VALIDATION REPORT ON POST-REGISTRATION CHANGES (PRCs)

Title and reference number of the project activity	75MW Yunnan Nuozu Hydropower Project
Process track	<input type="checkbox"/> Prior approval <input checked="" type="checkbox"/> Issuance <input type="checkbox"/> Renewal of crediting period
Version number of the validation report on PRCs	Version 01
Completion date of the validation report on PRCs	08/02/2017
Type(s) of PRCs	<input type="checkbox"/> Temporary deviations from the registered monitoring plan, monitoring methodology or standardized baseline <input type="checkbox"/> Corrections <input type="checkbox"/> Changes to the start date of the crediting period <input type="checkbox"/> Inclusion of a monitoring plan to a registered project activity <input checked="" type="checkbox"/> Permanent changes from registered monitoring plan, monitoring methodology or standardized baseline <input type="checkbox"/> Changes to the project design of a registered project activity <input type="checkbox"/> Types of changes specific to afforestation and reforestation project activities

CCCI has performed the validation on post-registration changes for 75MW Yunnan Nuozu Hydropower Project, CDM

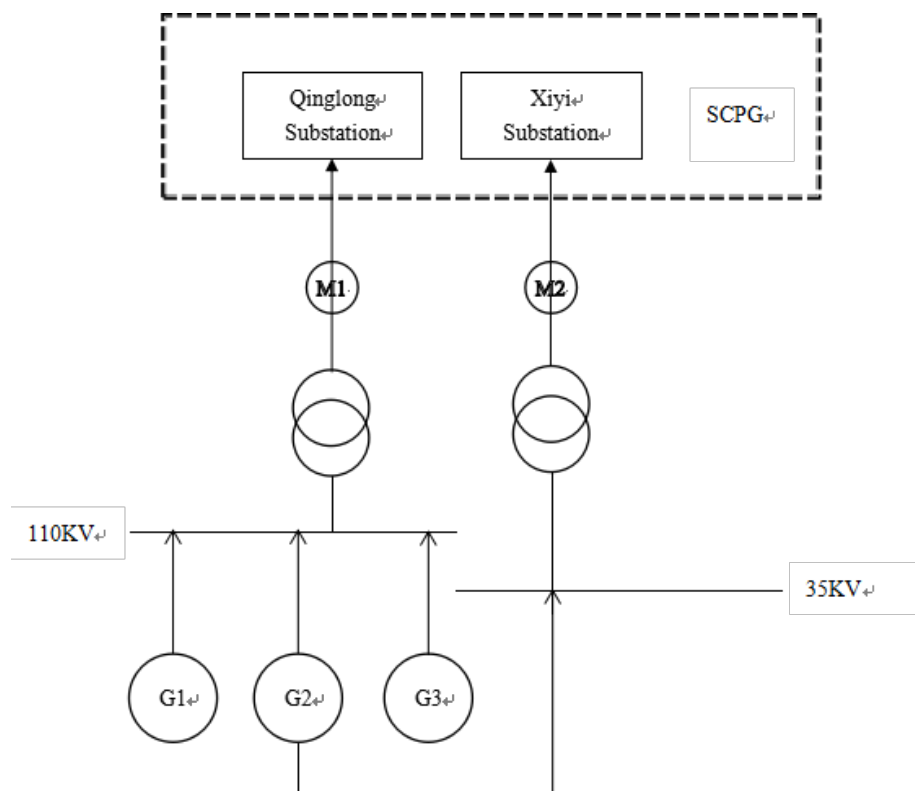
By reviewing the revised PDD version 03.0 /2/ and the registered PDD Version 02.0 /3/, the permanent changes from registered monitoring plan are summarized as: according to the PPA signed with the power grid /7/, the electricity generated by the project activity is connected via one 110KV line to Qinglong substation and one 35KV line to Xiyi substation, which is different from the two 110KV lines connected with Qinglong substation and Xiyi substation in the registered PDD. Furthermore, the location of the two main meters (M1 and M2) has been changed from the high voltage side of the transformer in the project site to Qinglong substation and Xiyi substation.

Based on the onsite inspection, the verification team can confirm that the generated electricity is exported to SCPG via the 110KV line and one bidirectional electricity meters (M1) with accuracy class of 0.2S was installed at Qinglong substation, and the 35KV transmission line is still not finished. The meter installed at Qinglong substation (M1) measure both the electricity delivered to SCPG ($EG_{out,y}$) and the electricity imported from SCPG ($EG_{in,y}$). The meter installed at Xiyi substation (M2) will be applied after the 35KV transmission line connects to SCPG.

Please refer to the below diagram for an overview on how the project activity is connected to the grid, and the location of the electricity meters as described above.

Findings	No findings raised in this section.
Conclusion	<p>The validation team confirms:</p> <ul style="list-style-type: none"> ✓ The permanent changes to the registered monitoring plan described in the revised PDD /2/ are in compliance with the applied methodology /5/; ✓ The permanent changes from the registered monitoring plan do not reduce the level of accuracy of the monitoring compared with the requirements contained in the registered monitoring plan, and are unlikely to lead to a reduction in the accuracy of the calculation of emission reductions; ✓ The permanent change to the monitoring plan is of a type described in the Project Standard Appendix 1 /1/ that does not need prior approval.
